WBN-TS-99-014

WATTS BAR NUCLEAR PLANT (WBN) UNIT 1 - TECHNICAL SPECIFICATION  
(TS) CHANGE NO. WBN-TS-99-014 - STEAM GENERATOR ALTERNATE REPAIR  
CRITERIA FOR AXIAL OUTSIDE DIAMETER STRESS CORROSION CRACKING  
(ODSCC) - RESPONSE TO REQUEST FOR ADDITIONAL INFORMATION - (TAC  
NO. MA8635)

### WATTS BAR NUCLEAR PLANT UNIT 1 PROPOSED TECHNICAL SPECIFICATION CHANGE WBN-TS-99-014 ALTERNATE REPAIR CRITERIA (ARC) PRESSURIZATION RATE ISSUE RESPONSE TO NRC REQUEST FOR ADDITIONAL INFORMATION

Figure 1: Repeat of Figure 3.8 of the TVA report.

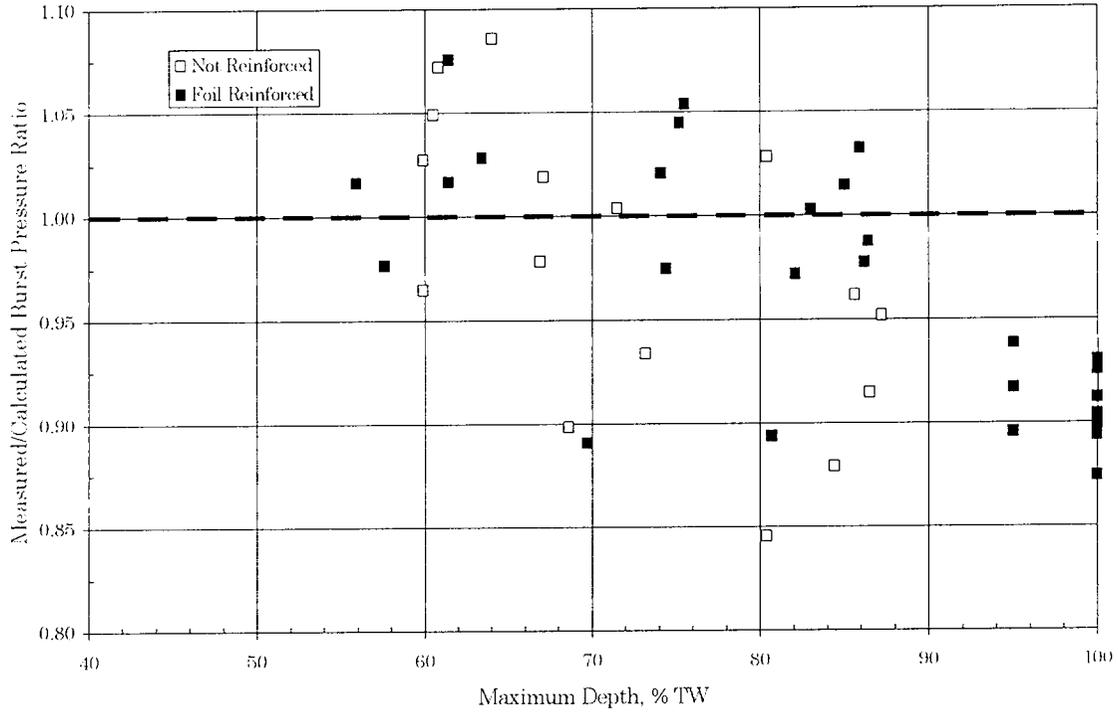
For Figure 3.8 of Enclosure 3, which was derived from Table 3-1, please address the following:

- a. For the indications with maximum depths between approximately 65% and 85%, the predictive model underpredicted the burst pressures for specimens tested without foil. In Enclosures 3 and 4, it was indicated that the Cochet equation may overpredict the burst pressure of partial through-wall cracks that do not end in full thickness material. In addition, it was indicated that the Cochet equation provides a conservative prediction of the burst pressure. Please address whether the underprediction for the 65% to 85% through-wall specimens tested without the foil is attributed to the limitations of the Cochet equation (related to cracks that do not end in full thickness material) or some other mechanism. If the underprediction is due to this effect, wouldn't it be more appropriate to compare the mean of the data for a specific depth (or a small depth range) for those specimens tested without a foil to the mean of the data for the same depth for those specimens tested with a foil to assess the effect of a foil for this specific geometry? If this were done, would it

alter the conclusion that a foil effect is being observed and/or its magnitude?

- b. Given the scatter in the burst pressure data for any given depth (approximately 5 to 10% in the burst pressure), discuss whether normalization of the data (to a mean curve) is appropriate and/or whether more testing needs to be performed to reach the conclusions drawn in the report.

- c. The staff notes that the tests depicted in Figure 3.8 were performed at slow pressurization rates and the tests indicating a foil effect were done at fast pressurization rates. These latter tests compared "fast-foil" tests to "slow-no-foil" and "fast-no-foil" tests. See Question 4.

A copy of Figure 3.8 is included as Figure 1 of this document. A review of the figure does effect a comparison of the means of the foil and no foil tests across the full range of depths. It is also apparent that there is a trend for the model to over estimate the burst pressure for the deeper specimens regardless of the presence of a foil reinforced bladder during the test, i.e., the data trend downward from left to right on the figure. A clearer comparison is apparent from an examination of Figure 3.7 of the report, which is included herein as Figure 2 for your convenience. Figure 2 illustrates the results from both models against an ideal prediction line and shows the results of performing a linear, 1<sup>st</sup> order regression analysis of the measured burst pressures on the predicted burst pressures. It is apparent from the figure that neither the slopes nor the intercepts are significantly different when separate regression analyses are performed for the no-foil and foil data.

The use of any normalizing equation leads to the conclusion that "the systematic deviation from the prediction model (Cochet or ANL) is the same for foil and no foil specimens." In other words, there is no detectable foil effect in the TVA specimens, and that finding extends to the ODSCC database because of the length of degradation involved.

It must be stressed that a comparison of the relative merits and or limitations of the normalizing equations, Cochet or ANL, is not relevant to this discussion, only that any systematic deviations of test data from the model used do not depend on whether or not the cracks or slots end in full thickness material. Because the trend of the data is consistent, it is not considered necessary to segregate the data into depth bands for comparison of foil and no-foil effects. This is supported by the information presented on the attached Figure 2.

Figure 1: Pressure vs. time history for a different specimen.

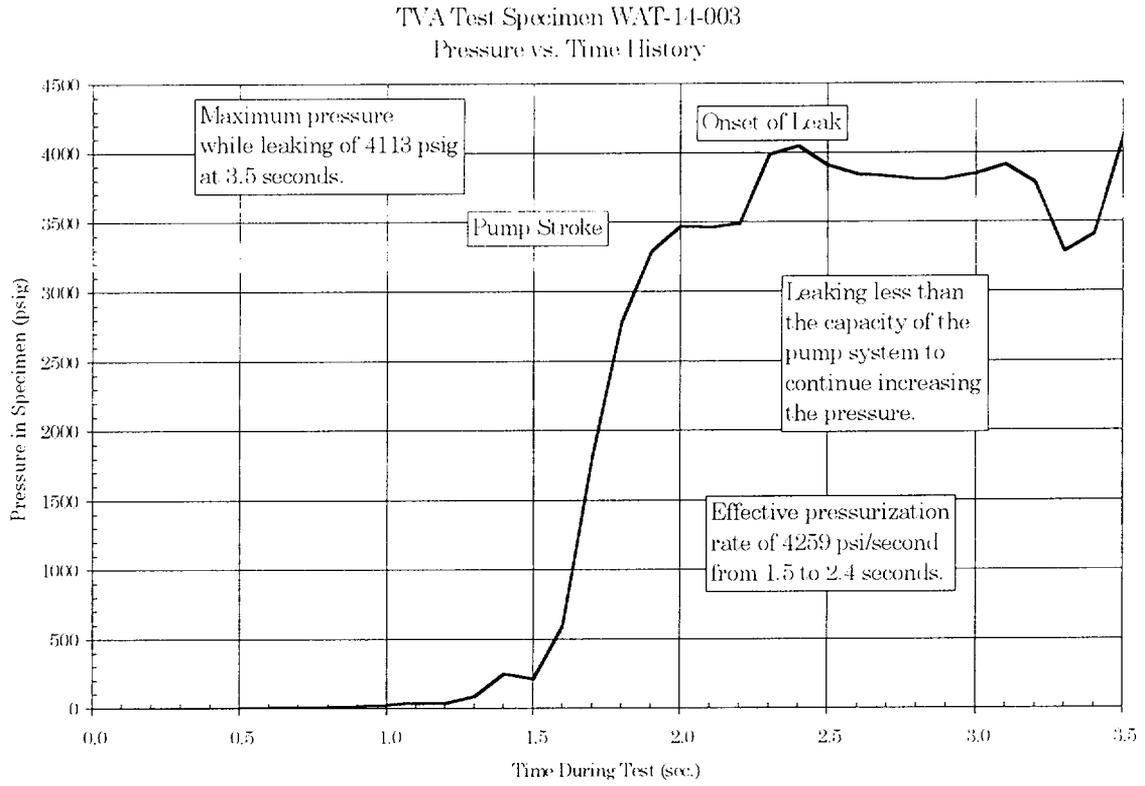
Figure 2.3 of Enclosure 3 represents a typical pressurization rate curve for the fast pressurization tests performed without the foil (this figure is actually a pressurization rate curve for a leak test). A review of this figure indicates that the pressurization rate prior to leakage was only on the order of 300 psi/sec rather than 2000 psi/sec. As a result, it appears to draw into question the conclusion that there is no pressurization rate effect. The subsequent test of this tube would have been performed with a bladder and a different flaw geometry.

If the plot in Figure 2.3 is typical, it is not apparent that the results truly represent "fast pressurization rate tests without a foil" rather they may represent slow tests without a foil.

In light of the above, discuss the need to conduct slow pressurization rate tests with a foil so that a direct comparison of pressurization rates can be performed.

The inclusion of the pressurization rate figure for specimen WAT-14-001 as typical was not intended to imply that the rates for the specimens were identical. In fact, the figure illustrates the rate for the slowest tested specimen. The data on the figure show that the overall average pressurization rate for the specimen was about 1191 pounds per square inch per second (psi/s), i.e., the pressure started to increase at 1.8 seconds and reached 4044 psi at 4.9 seconds. For the pressure range from 3500 to 4044 psi the rate was about 454 psi/s, the lowest pressurization rate of any of the Type 14 models tested. Table 2 in Enclosure 1 of this letter, provides a listing of the salient pressure and time information from the records for each of the Type 14 specimens. The average rate ranged from a low of 1191 psi/s to a high of 6472 psi/s. Also listed in Table 2 are the ratios of the measured maximum pressure to the predicted maximum pressure for each model, which demonstrates that the ratios were not dependent on the rate of the test, e.g., the fastest test had the lowest ratio. Figure 1 of this enclosure illustrates the pressure versus time history for a specimen that had an effective pressurization rate in excess of 4000 psi/s. Figure 2 of this enclosure illustrates the pressure versus time history for the
